NIAGARA MOHAWK POWER CORPORATION

LICENSE NO. NPF-69

DOCKET NO. 50-410

Supporting Information and no Significant Hazards Consideration Analysis

GENERATION BUSINESS GROUP
PROPOSED NMPC NUCLEAR DIVISION MANAGEMENT STRUCTURE

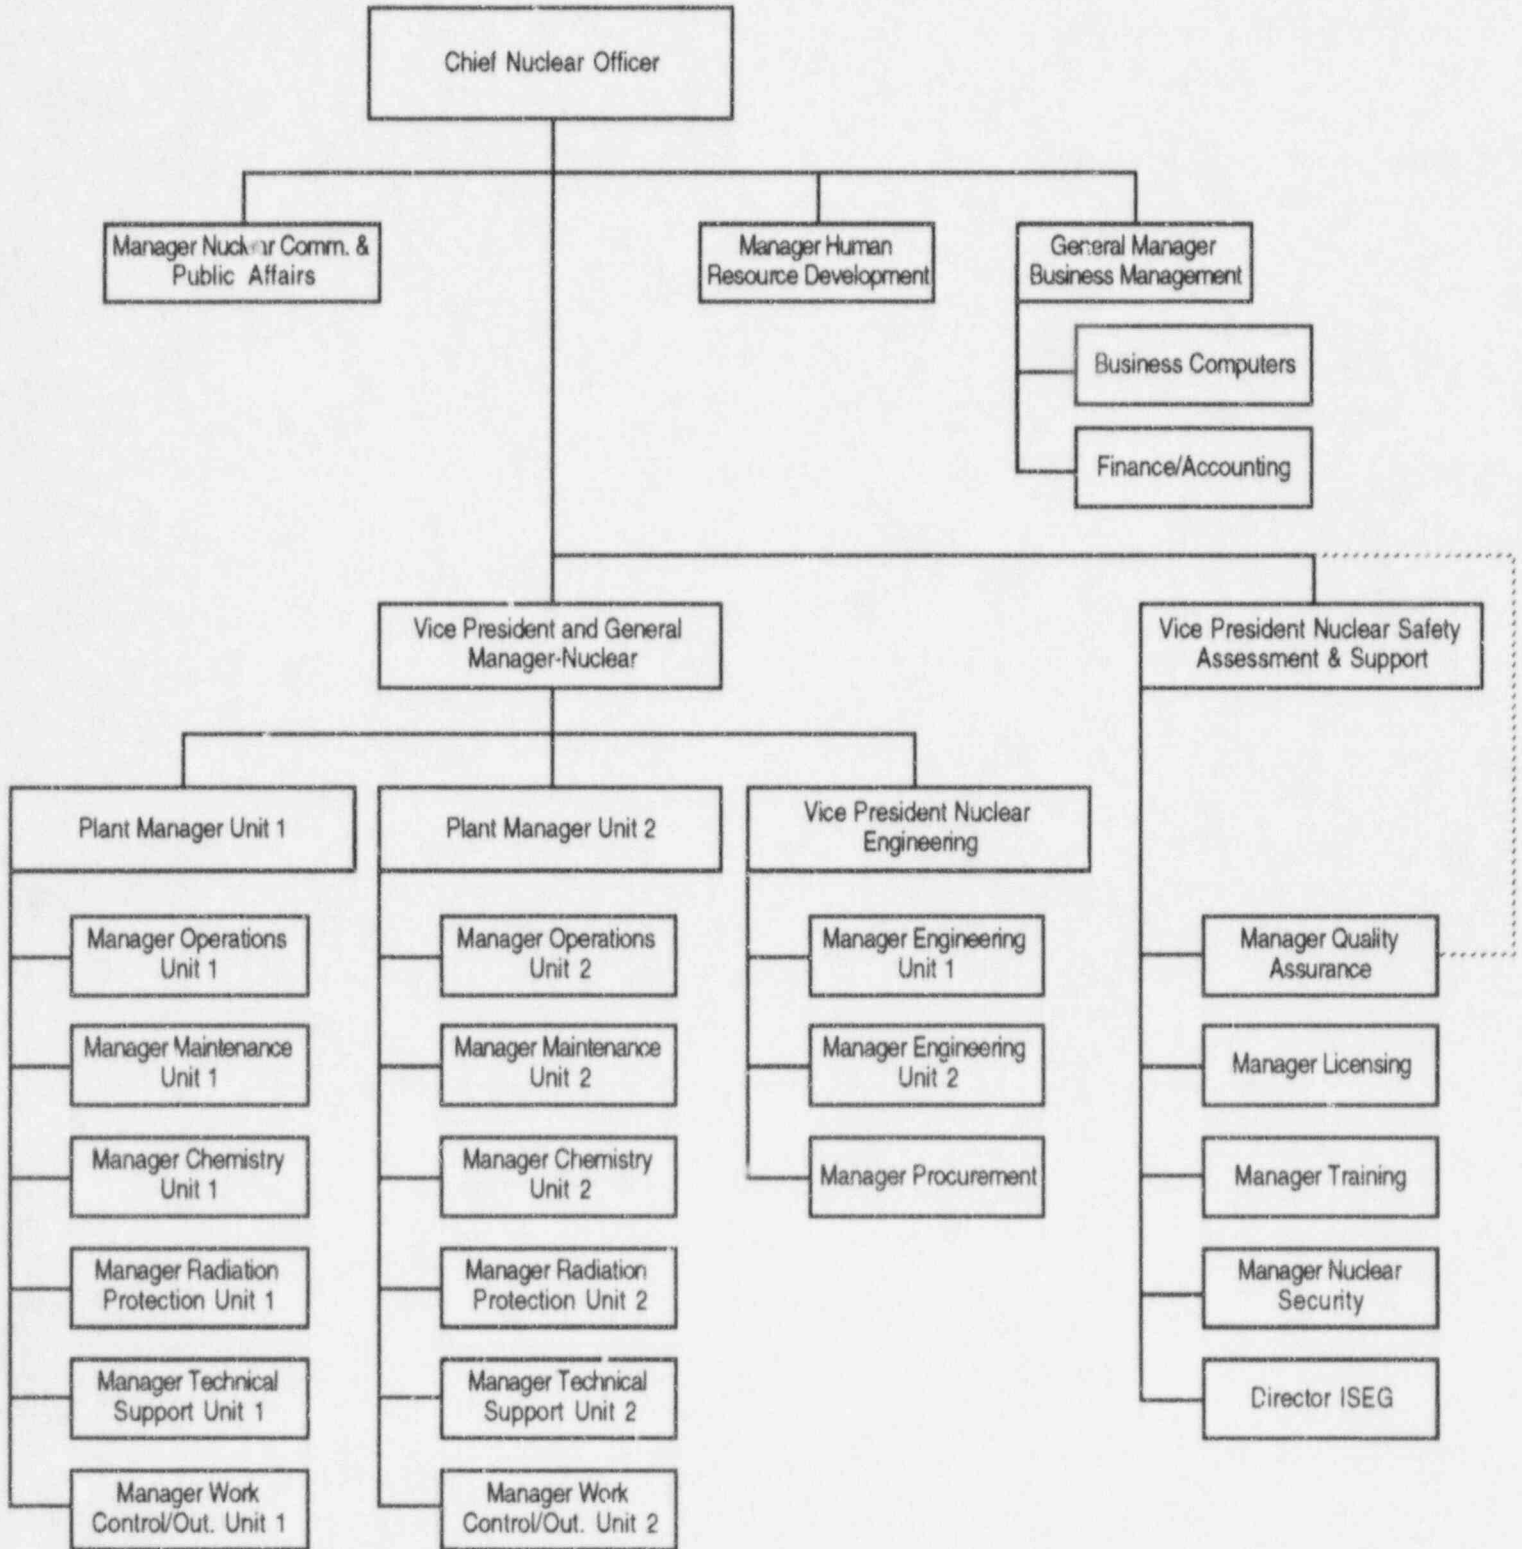
The proposed Technical Specification changes to Sections 6.1, 6.2, 6.5, 6.6, and 6.7 reflect the restructuring of the Niagara Mohawk Power Corporation (NMPC) corporate management organization. The proposed NMPC upper management Generation Business Group is reflected on Attachment C. The proposed NMPC Nuclear Division management structure is reflected on Attachment D.
